2-E-25-HZ
APPLICATION FOR CERTIFICATE OF APPROPRIATENESS

1115 Gratz St. 37917
Fourth and Gill H

Original Print Date: 2/10/2025
Knoxville/Knox County Planning -- Historic Zoning Commission

Removal of the original rear (left side) entrance and screen door. Applicant states the house has settled, rendering the door inoperable. Installation of a new 12" wide by 72" long, wood, fixed window in its place. In-kind brick will be installed to enclose the remainder of the original door opening.

view from driveway

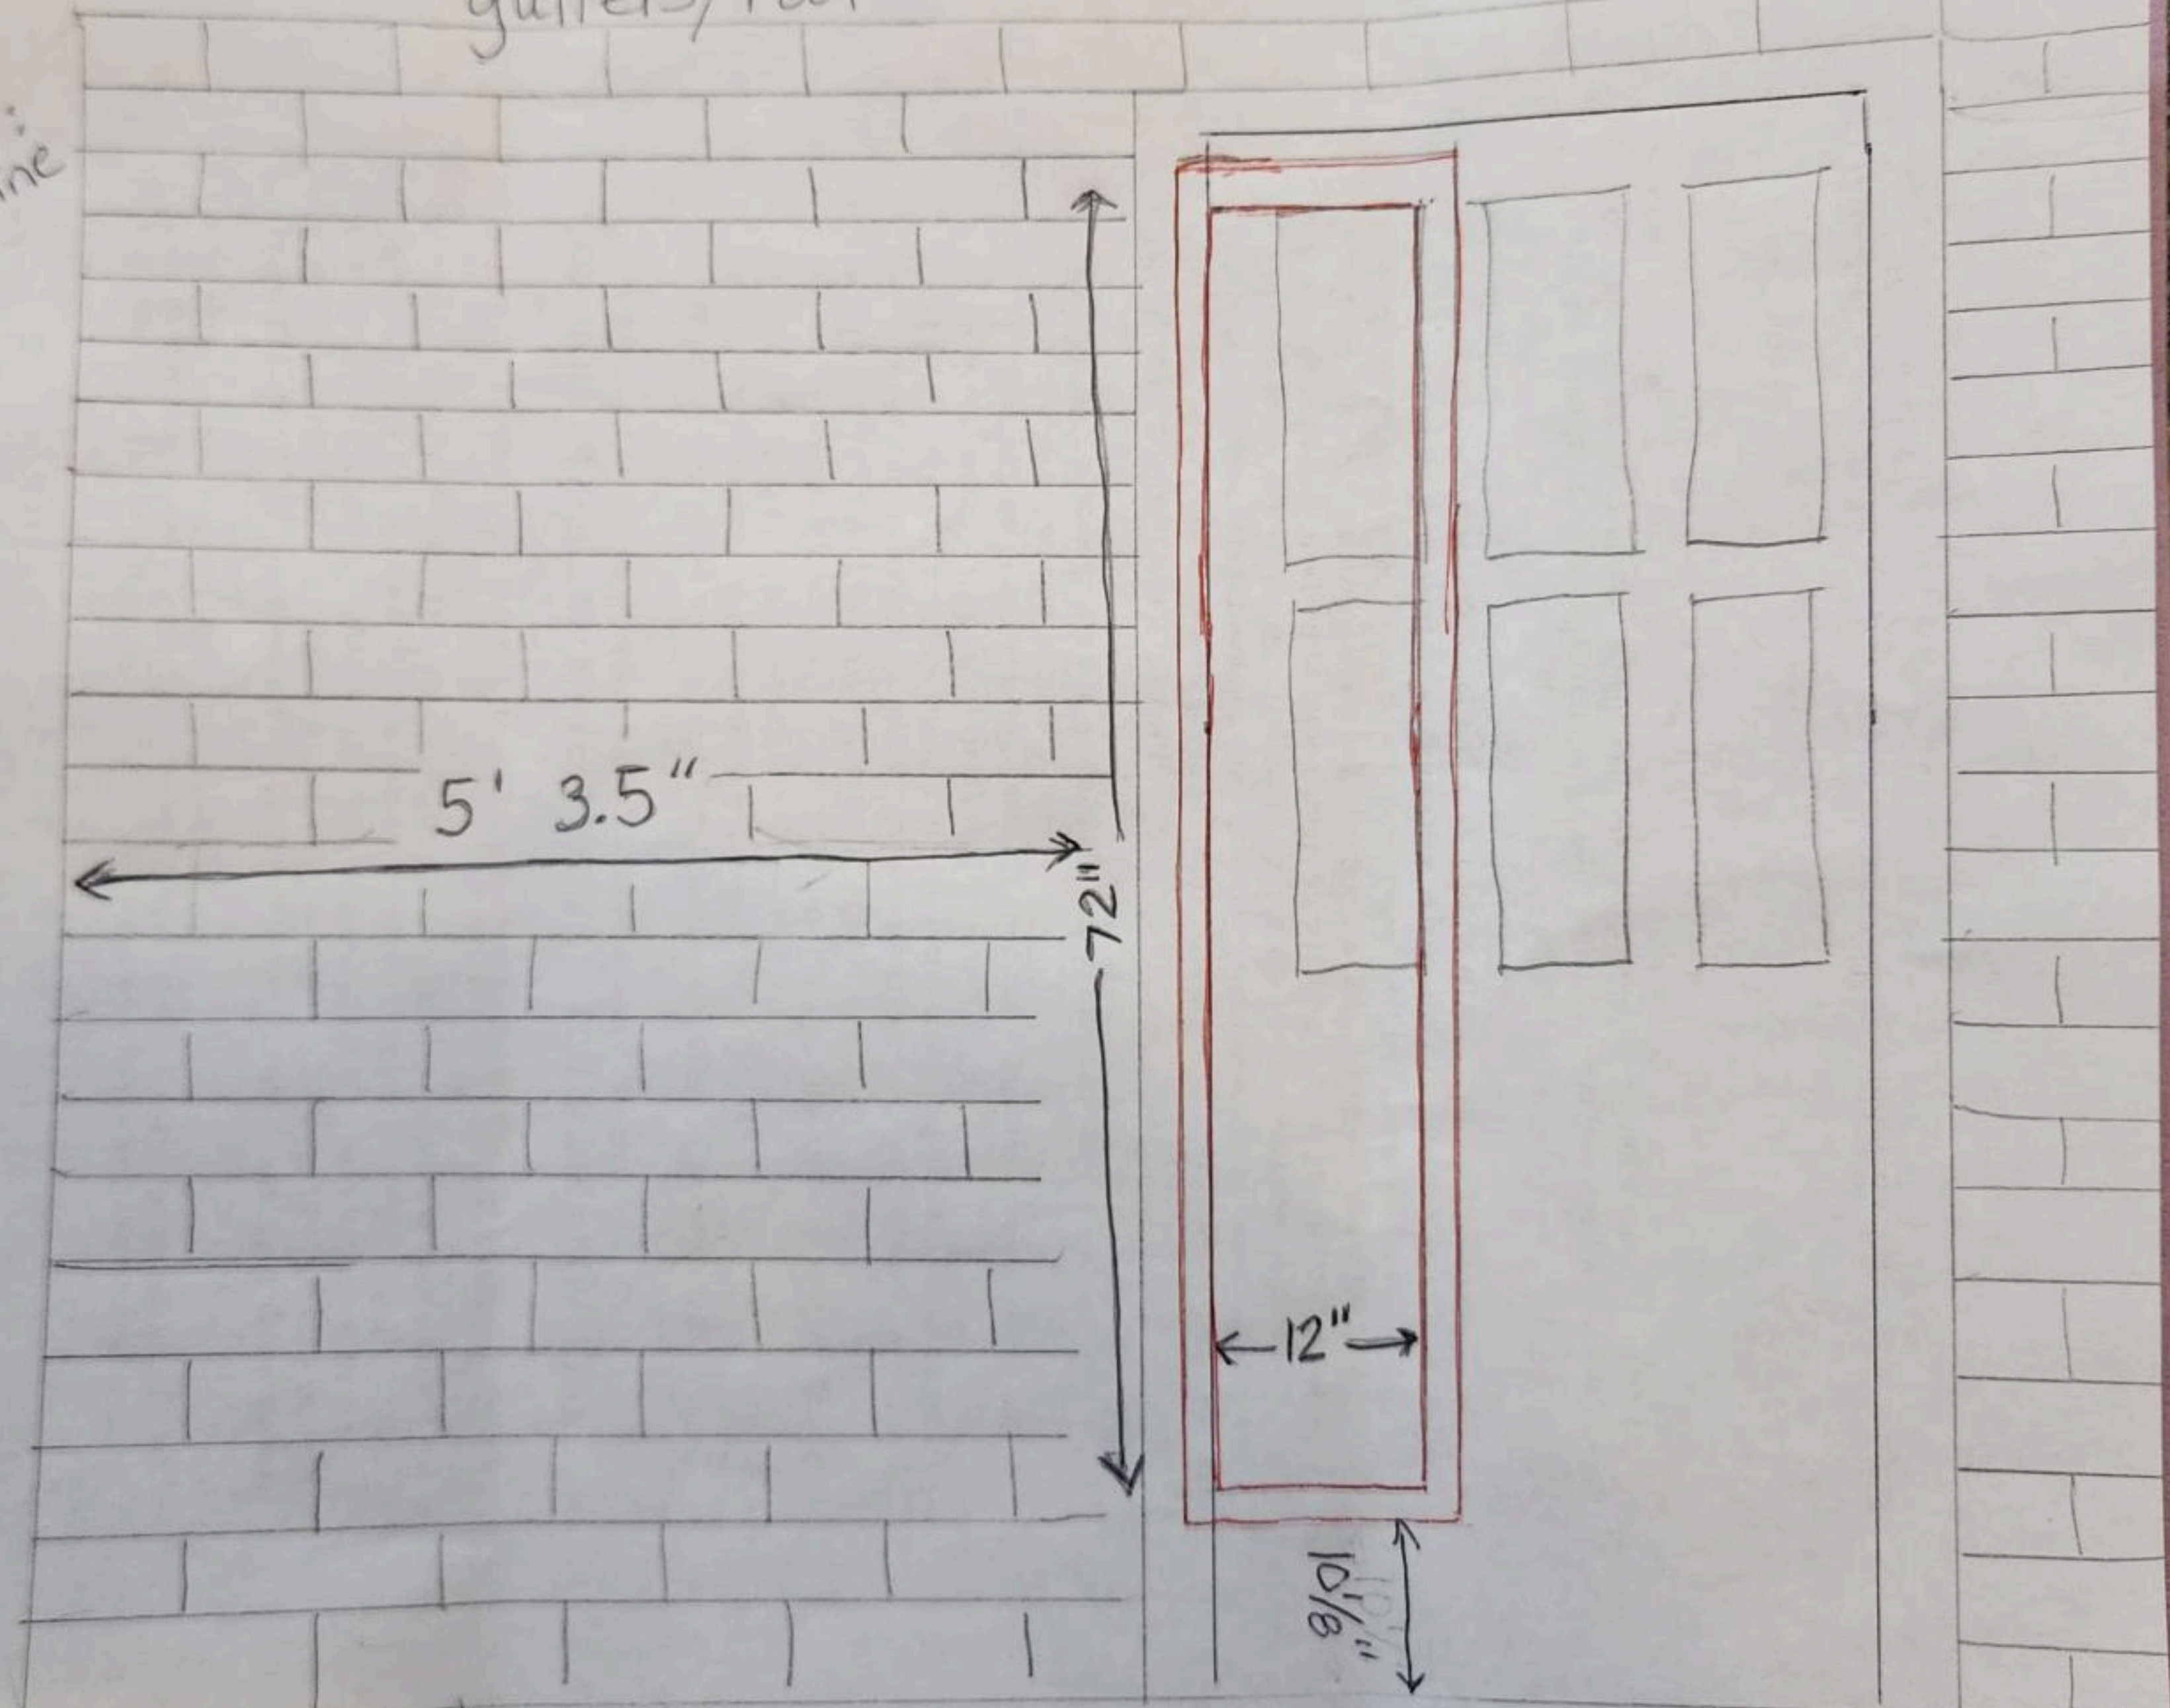
2. The proposed scope of work will be located on a secondary elevation, recessed towards the rear of the left (south) side elevation). The door to be partially enclosed is an original opening, with a seemingly original or historic secondary door. The area is minimally visible from the right-of-way.

3. Guidelines recommend that additional windows on secondary elevations be compatible with the overall design of the building. The proposed window to be installed is compatible with the original house in materials (a glass window with a wood frame) but the long, narrow (12" wide by 72" tall) window is not compatible with the Craftsman-style house. The proposed window type may be more compatible with a Ranch or contemporary design. A more compatible window may be one that is similar in size and design to the six-light opening on the existing/historic door, or a 6/6 double-hung wood window similar to the house.

Staff recommends approval of Certificate 2-E-25-HZ, subject to the following condition: 1) selection of a new window more compatible in size and design with the overall design of the building, to be submitted to staff for review.
